## *Fiesta '96 with 1,8 Endura-DE-engine, build year 08.95 – 10.96*

Squealing generator belt / discharged battery

Bulletin

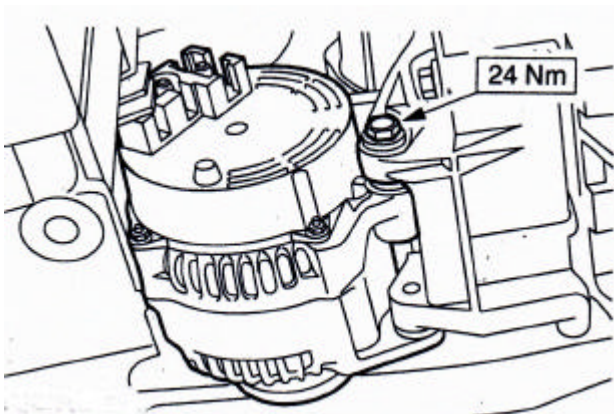
The cause of the problem is a broken generator bracket, which must be changed. Additionally a new screw with a flat washer, for the generator, must be fitted.

1. Remove the generator
2. Remove the generator bracket (4 screws)
3. Fit the new mounting, dispose of the old one
4. Fit the generator with the new screw

The lower rear mounting screw must be fitted to the lower front and the new screw, with the flat washer, must be fitted to the lower rear mounting.
